NOTICE OF DECISION
 Columbia River Carbonates – Storage and Loadout

Land Use Application Nos.:	SPR 21-008 (Site Plan Review – Type 1)
Applicant:	Columbia River Carbonates Braden Wale 300 North Pekin RD Woodland, WA 98674
Property Owner:	Columbia River Carbonates 300 North Pekin Road Woodland, WA 98674
Site Location:	289 North Pekin Road Woodland, WA 98674
Parcel & Size:	507350116, 10.06 acres
Zoning Designation:	Heavy Industrial, I-2
Date Application Received:	September 8, 2021
Notice of Application & Likely DNS issued:	N/A
Comment Period & SEPA Appeal Period Ended:	N/A
Notice of Decision Issued:	September 27, 2021
DRC Decision:	Approve with Conditions

PROJECT TITLE
CRC Pelletizing Plant
Civil
Pelletizing Plant Expansion
Site, Grading & Storm Drainage Plan

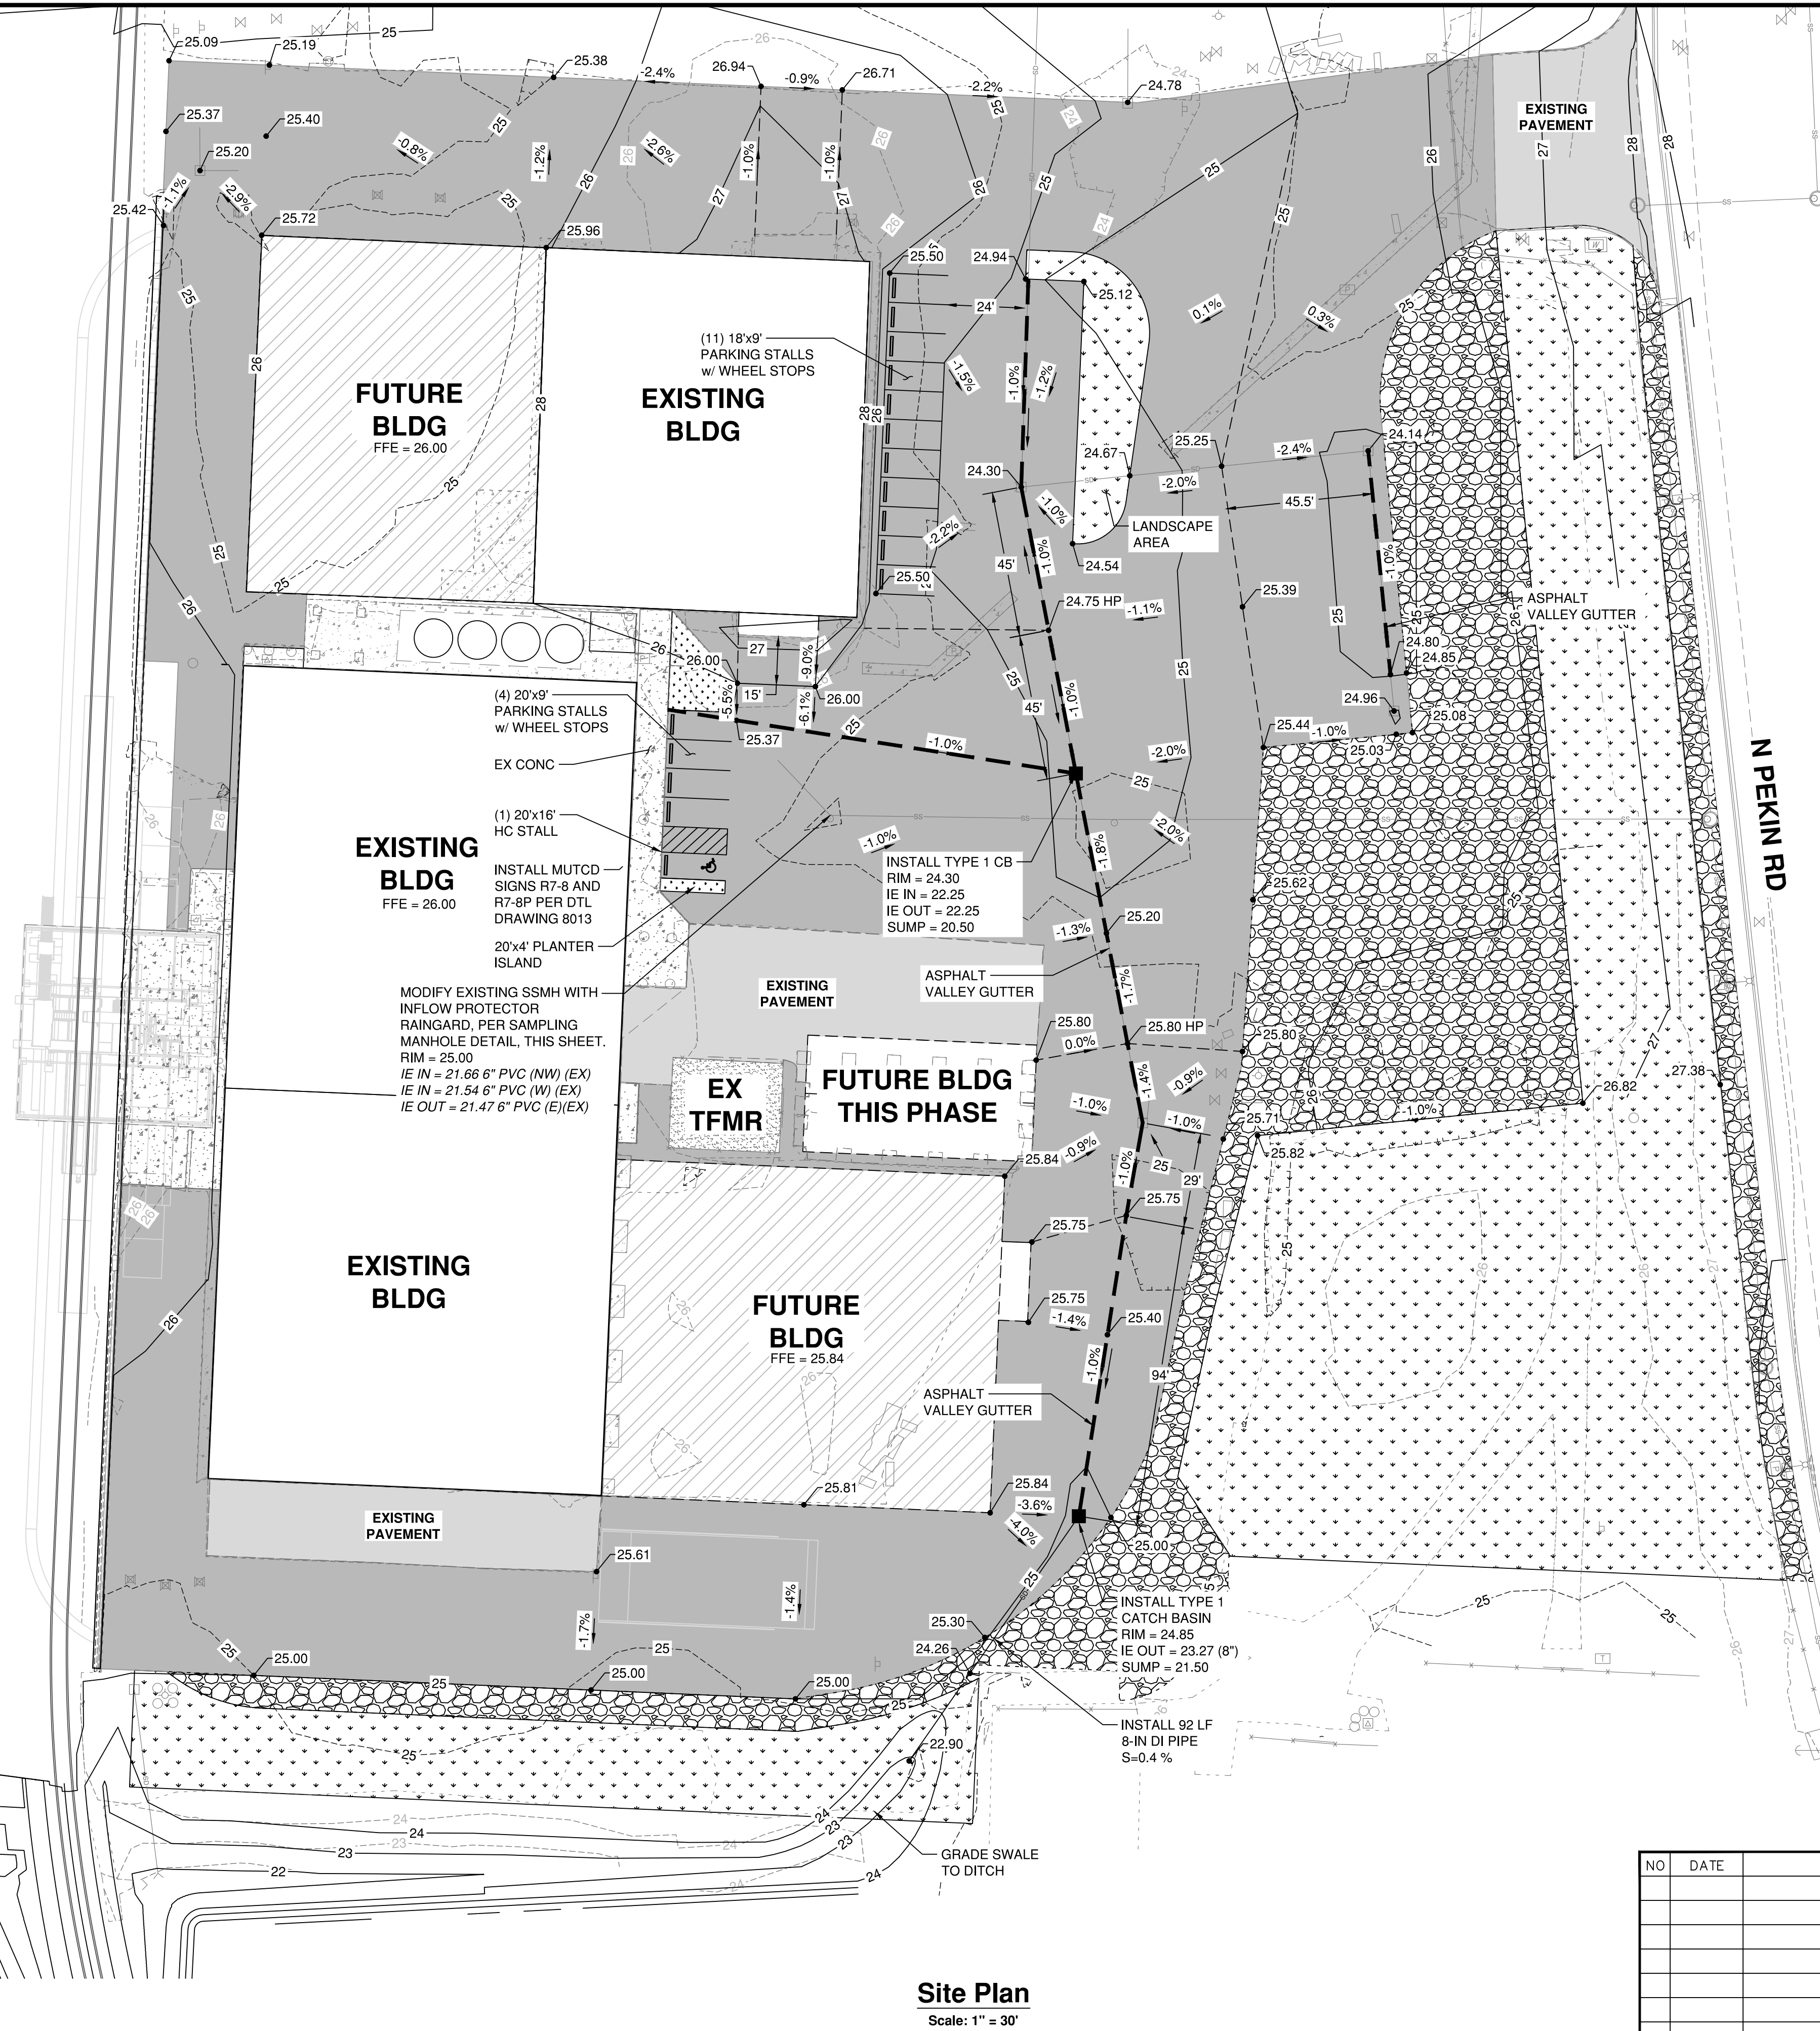
Finding 10: A preliminary erosion control plan was not included with the preliminary site plan submittal. A condition of approval is added to meet all erosion control requirements of WMC 15.10 and follow the Woodland Design Standards for the erosion control plan. *See Condition #5.*

Finding 11: The applicant's submittal includes narrative indicating that stormwater management on the site has been adequately addressed by a stormwater Technical Information Report (TIR) and stormwater treatment and detention facilities completed as part of a previous project phase, and that no improvements to the existing conveyance, treatment or detention facilities on the site are required for the current phase of the work. This appears to be an accurate assessment; hence, a new TIR is not required. A condition of approval is added that all proposed site modifications must be consistent with the assumptions in the previous TIR and all proposed site drainage improvements must comply with WMC 15.12 and the City Engineering Standards. *See Condition #6.*

5. A final erosion control plan will be required with final engineering. Applicant is required to install and maintain erosion control measures per the Best Management Practices as outlined in WMC 15.10.

6. All proposed site modifications must be consistent with the assumptions in the previous TIR and all proposed site drainage improvements must comply with WMC 15.12 and the City Engineering Standards

Overall Landscape Plan

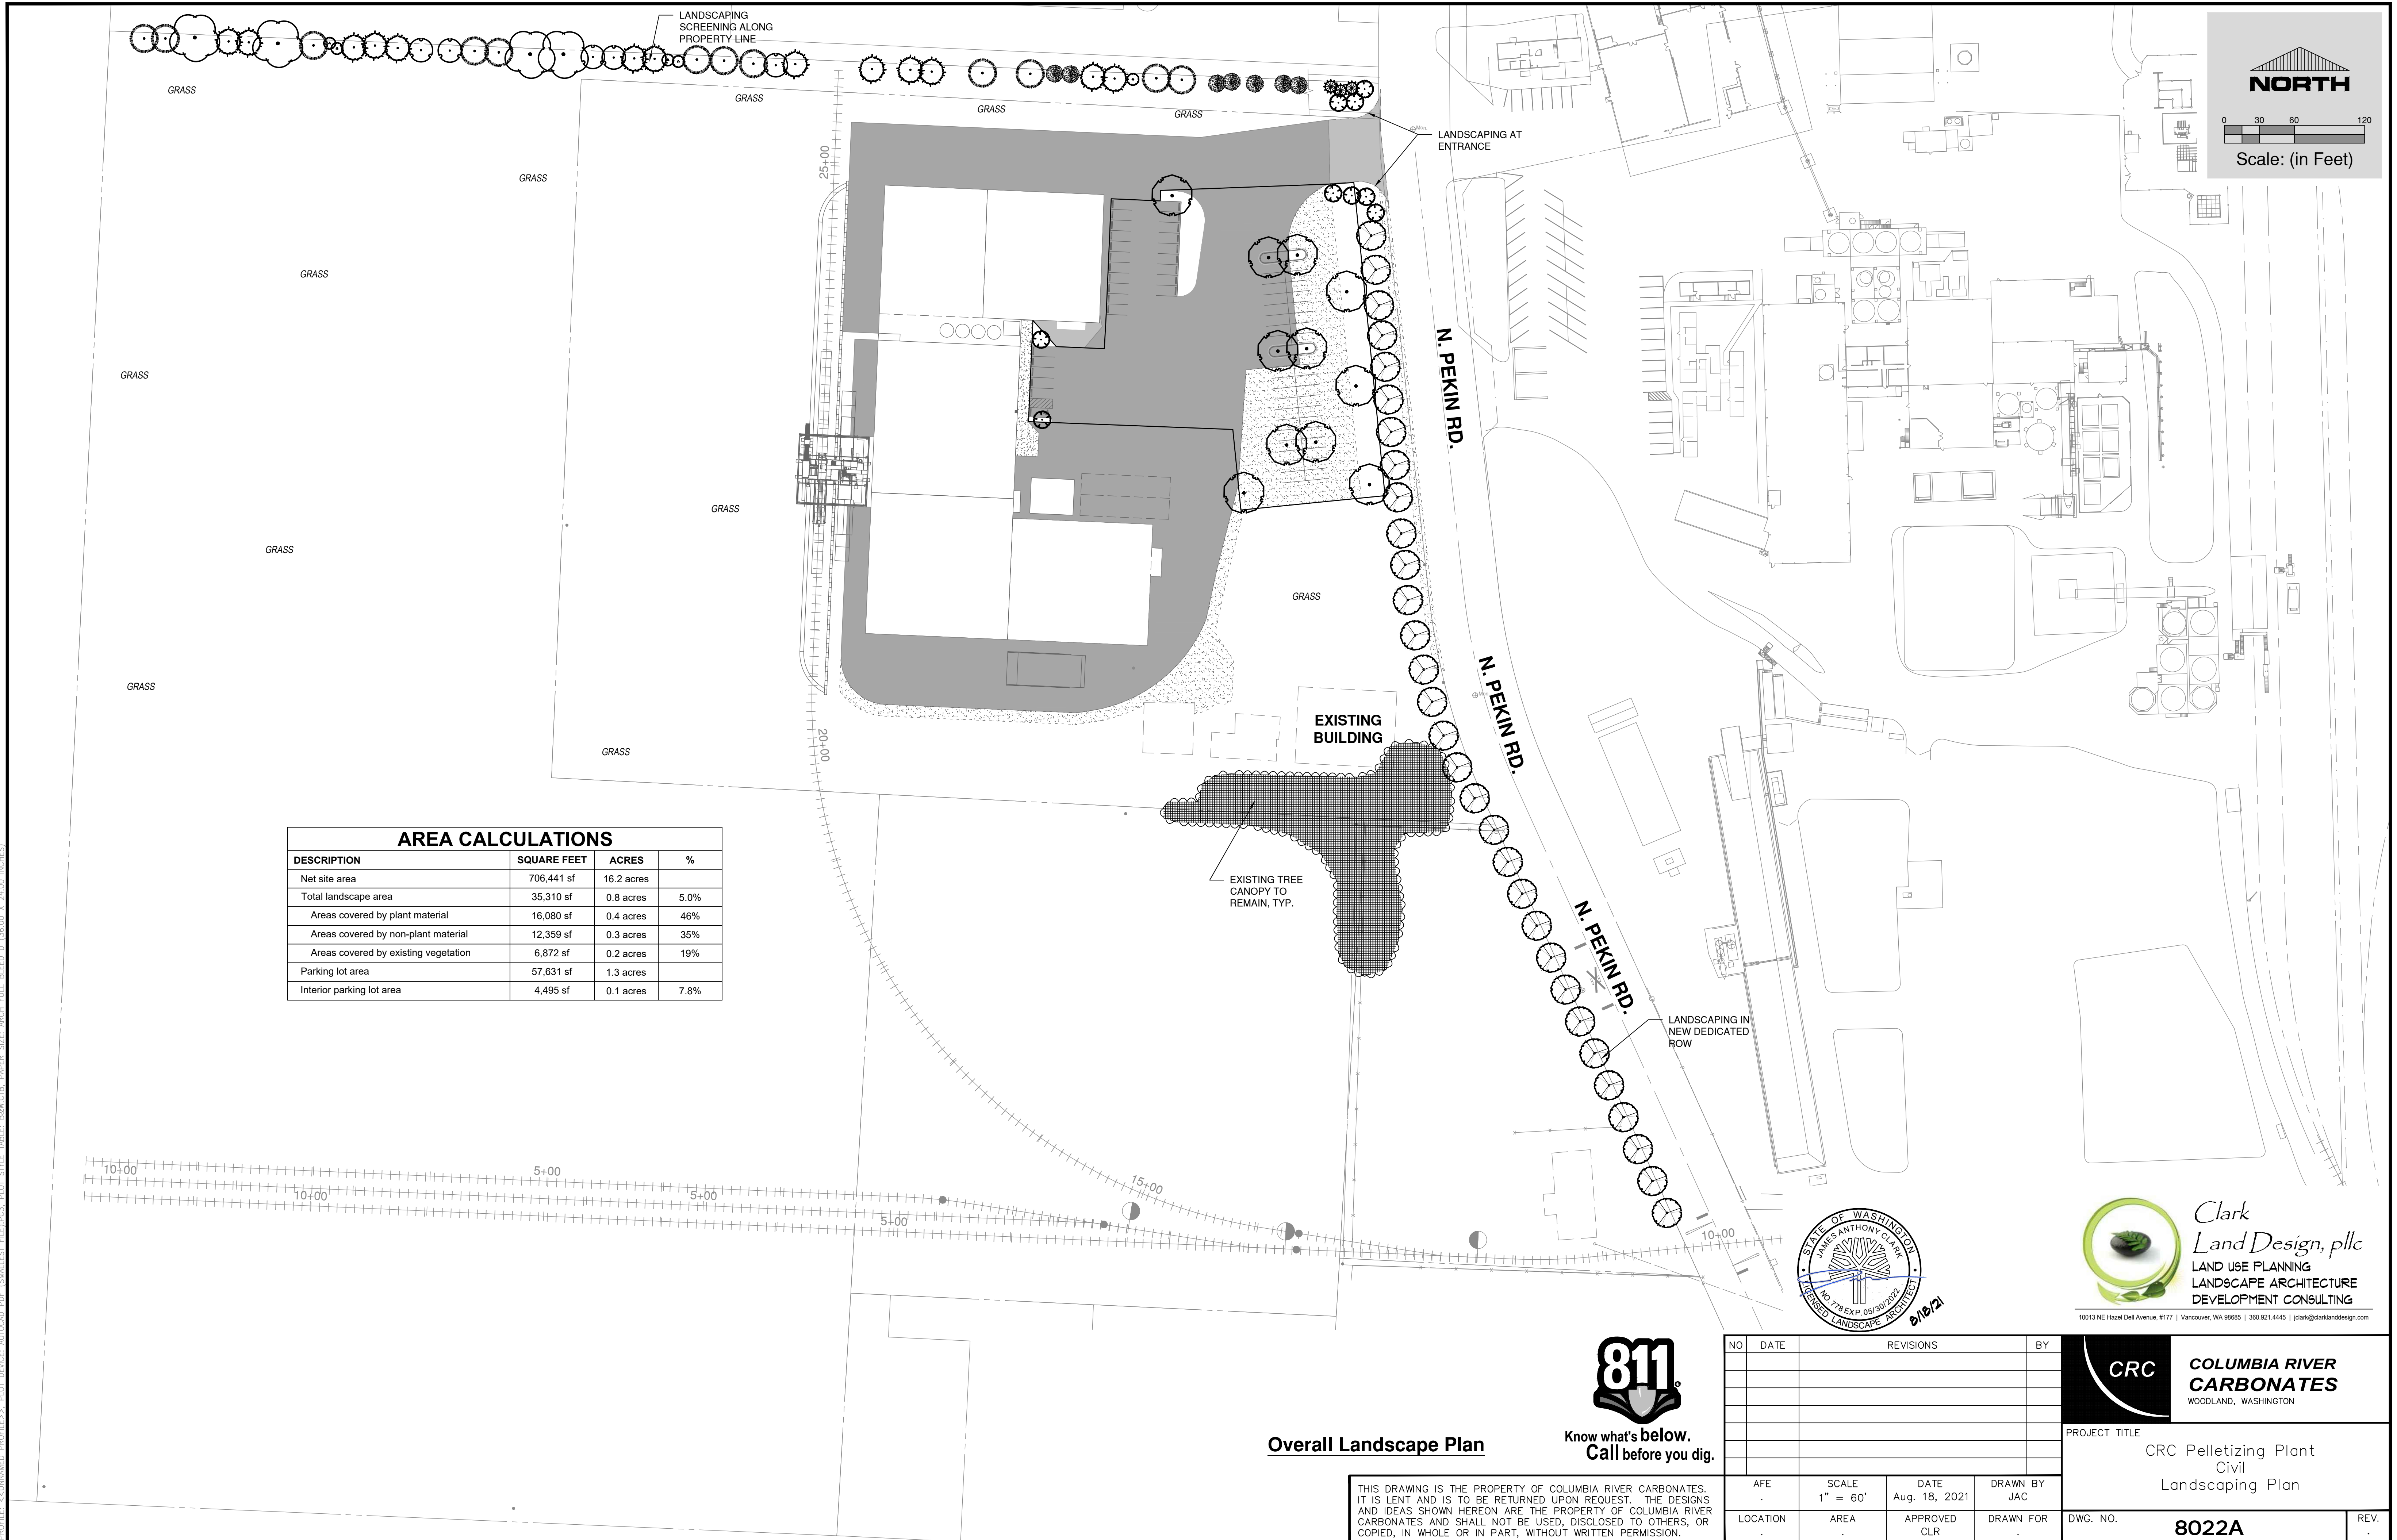
Finding 17: The proposed landscaping plan shall include tabulation showing the area and percentage of the following, per WMC 17.46.124:

Finding 21: Per WMC 17.46.125 (E), trees shall have a minimum diameter or caliper measured at four feet above grade of two inches or greater at time of planting and shall be densely planted as certified by a certified landscaping professional.

Finding 22: A majority the trees indicated on the landscaping plan meet the size requirement. Some trees listed are sized by gallon rather than caliper. Two of the proposed trees are only 1-in. caliper. However, staff acknowledges that available stock from nurseries can vary and strictly adhering to 2-in. caliper may be challenging. The proposed plant schedule is acceptable.

Finding 23: Per WMC 17.46.125 (F), shrubs shall be planted from a five-gallon container or larger at the recommended spacing as certified by a certified landscaping professional.

Finding 24: Many, but not all of the proposed shrubs are indicated to be 5-gallons or larger. However, there is a wide variety of shrubs proposed. Staff acknowledges that obtaining all plants in 5-gallon size may be challenging and may result in a more limited variety of plants if strictly required. The proposed plant schedule and shrub sizes are acceptable.

Finding 28: Per WMC 17.46.126 (F), a minimum of ten percent of the total surface area of all proposed parking areas, as measured around the perimeter of all parking spaces and maneuvering areas, shall be landscaped. The proposed landscaping plan meets this minimum coverage requirement.

Finding 29: At a minimum, one tree per five parking spaces shall be planted to create a partial tree canopy over and around the parking area. All parking areas with more than twenty spaces shall include landscape islands with trees at both ends and in between to break up the parking area into rows of not more than ten contiguous parking spaces.

Finding 30: The proposed parking lot consists of 16 parking spaces and 10 trees.
